1992 Corvette ZR-1: Service Bulletin: Lack of Wide Open Throttle Engine Underpower

Subject: LACK OF WOT-LOW ENGINE POWER REVISED CABLE ADJUSTMENT PROC.

Model and Year: 1992 CORVETTE ZR-1 WITH 5.7L ENGINE AND MANUAL TRANSMISSION

Bulletin Number: 92-214A-7B - (07/01/1992)

Cable Adjustment Mechanism

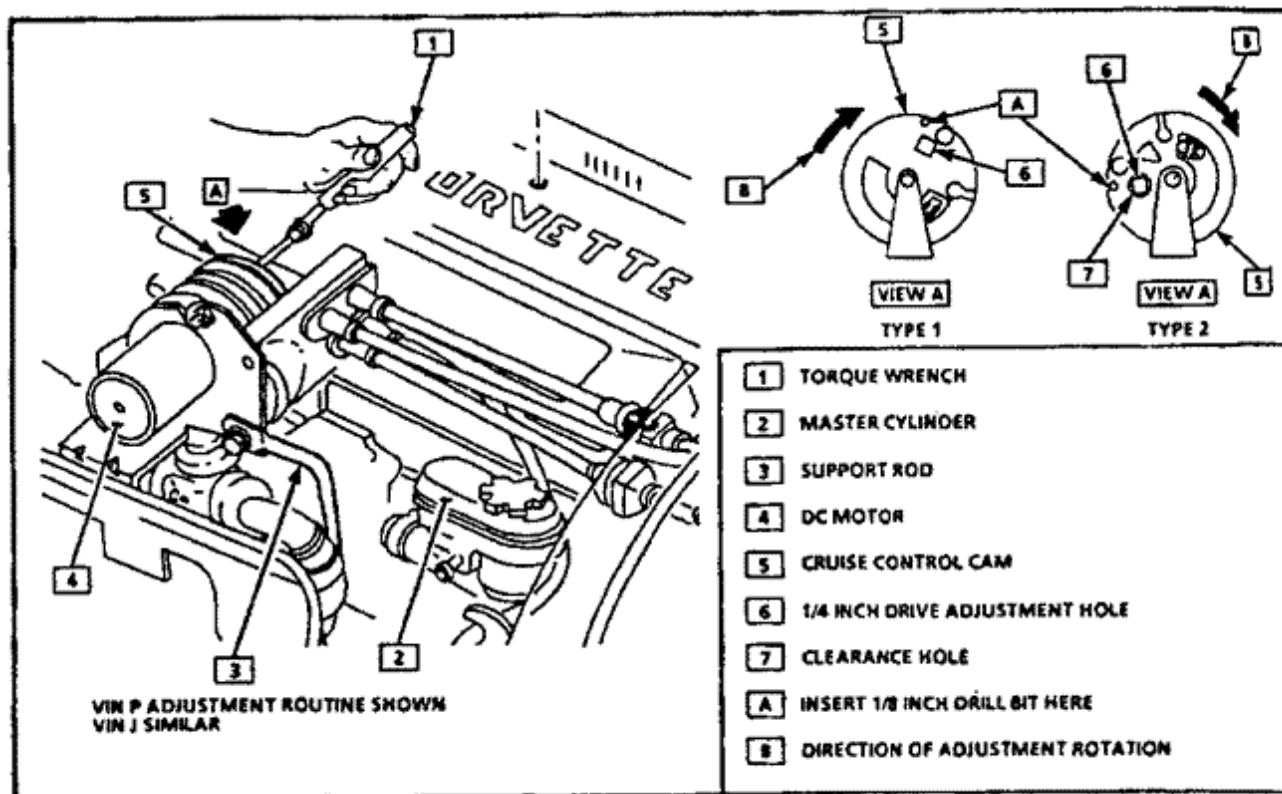
1. Remove adjuster cam assembly splash cover, foam shield, and cable cam cover.
2. Disconnect cruise control cable from the cruise control servo.
3. Depress reset button on the throttle control cable and fully extend cable sheaths (see figure).
4. Insert a 1/8 inch drill bit into adjuster assembly alignment hole (see figure, item A).

5. Insert a torque wrench with a 1/4 inch drive extension into square hole on the cruise control cam (type 1) or through the cruise control cam into the accelerator cam (type 2) (see figure, item 6).
6. Turn the torque wrench clockwise until obtaining a torque of 4 N.m (35 lbs. in.). During adjustment, several clicks of the adjuster should be heard. If not, repeat step 3.
7. Remove the torque wrench AND drill bit.
